ADDENDUM NUMBER 2

NOTIFICATION DATE:	BID TITLE:	BID NUMBER:	BID OPENING DATE & TIME:
03/14/14	WRF Aeration Monitor & Control Instrumentation Improvement	14-025	03/25/14 2:00 PM

CITY OF NAPLES, FL
CITY OF NAPLES WRF AERATION MONITOR & CONTROL INSTRUMENTATION IMPROVEMENTS
AERATION BASINS

E-101

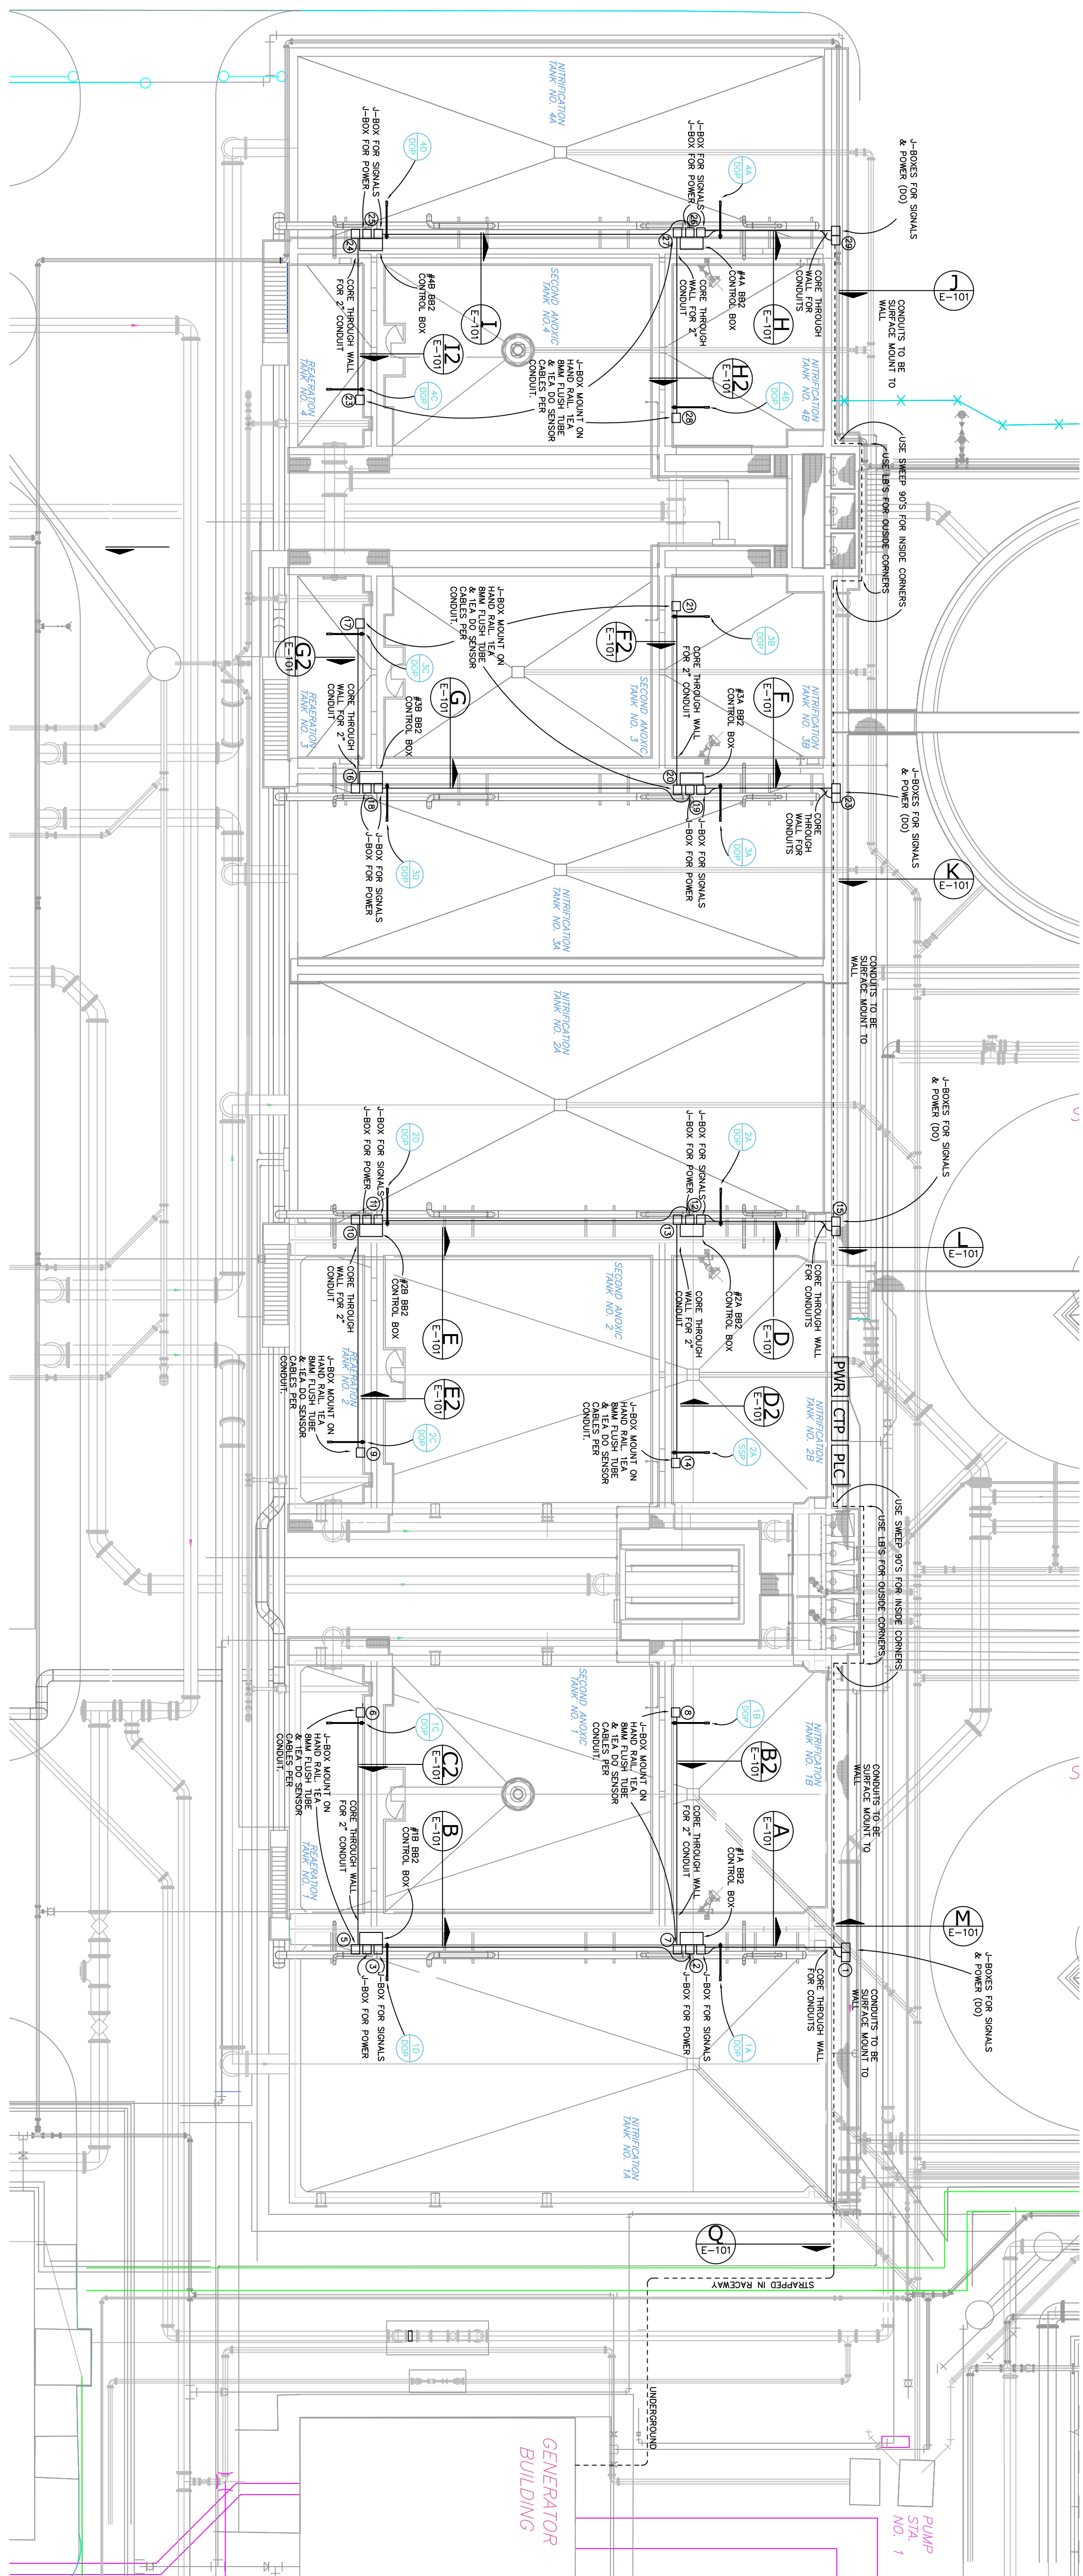
Attached in Exhibit B please find the updated Sheet E-101 with a device label correction. In Nitrification Tank 2B, Device Label 2A/SSP is changed to 2B/DOP.

- 1) The new PLC, CTP and PWR enclosure sized scaled from sheet E-101 indicate a 20 inch wide enclosure. Preliminary panel design indicates 48 inches required for the CTP and 42 inches for the PLC. What is the maximum enclosure size permissible?

ANSWER: The PLC, CTP, and PWR enclosures shown on Sheet E-101 are Not to Scale. The enclosures shown of Sheet E-101 were depicted for location ONLY. Sheet E-002, right hand side notes, clearly defines the sizing requirements for each of the enclosures.
